**TO:** Kate Rao, U.S. Environmental Protection Agency, Region IX  
**FROM:** James Walker, James Walker Environmental Consulting/Horsley Witten Group  
**DATE:** May 27, 2014  
**SUBJECT:** Technical Memorandum, Evaluation of Step-rate Test of the Hogback 18-43 Water Disposal Well Conducted on April 29, 2014

HOEDACK 18-43 SWD WELL  
STEP RATE TEST 4-29-14  
JIM WALKER REVIEW

SUMMARY OF TEST DATA  
HOGBACK 18-43 CLASS II DISPOSAL WELL  
APRIL 29, 2014

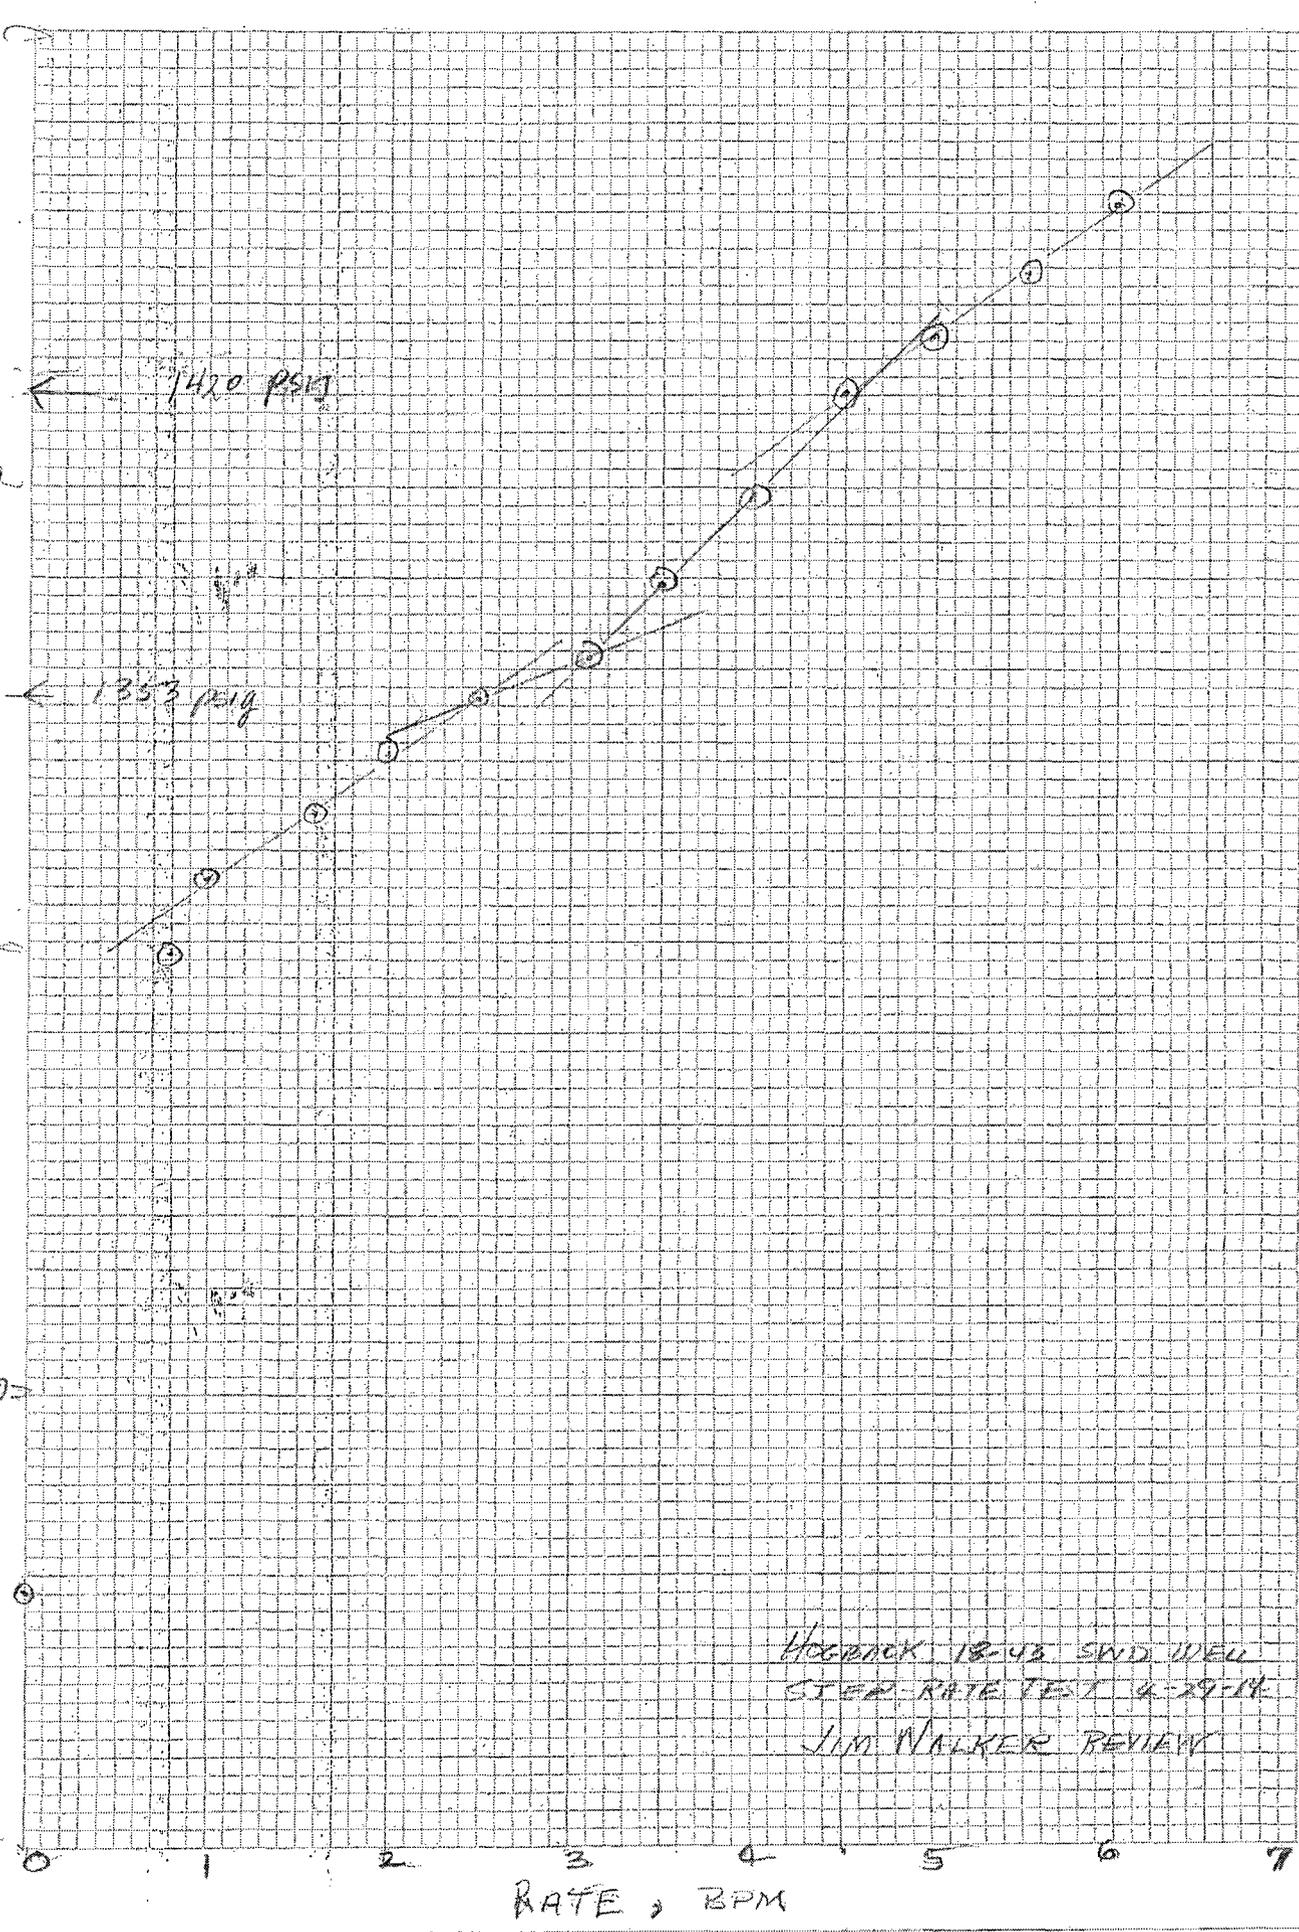
The results of the SRT are inconclusive because the bottom hole pressure versus rate plot fails to show a definitive break point and decrease in slope that would indicate the formation parting pressure had been reached. There are two points at which the slope decreases somewhat, but the changes are insufficient to definitively indicate a formation parting pressure had been reached. The pressures at those possible break points are approximately 1,353 and 1,420 psig. If that is a valid interpretation, it could indicate that an initial fracture occurred or opened at 1,353 psig followed by a secondary fracture at 1,420 psig in a more

fracture resistant interval. If available, it would be useful to review the pressure versus injection rate of the acid stimulation treatment to compare with the SRT results.

It is possible that the fracture pressure was not reached during the SRT. The maximum pressure imposed during the SRT was 1,462 psig, which equates to a pressure gradient of 0.68 psi/foot. The pressure gradients at the two possible break points are 0.63 and 0.66 psi/foot. Typical fracture gradients in consolidated sandstones such as those within the Entrada Formation are on the order of 0.70 psi/foot or greater. The current maximum allowable surface injection pressure is 425 psig, which equates to 1,354 psig at 2,160 feet and a gradient of 0.63 psi/foot without consideration of friction losses in the tubulars.

Limit the maximum allowable surface injection pressure to 400 psig, based on the lower possible break point of 1,353 psig on the SRT plot at 2.5 bpm and 404 psig wellhead pressure at that rate. That would allow a maximum injection rate of approximately 2.5 bpm or 3,600 bpd based on the SRT results. The maximum recent injection rate was only 445 bpd in October, 2013. That should allow ample excess capacity for injection rate increases in the future. The alternative is to rerun the SRT with a higher final injection pressure in order to determine whether the actual fracture gradient exceeds the highest pressure imposed in the recent SRT.
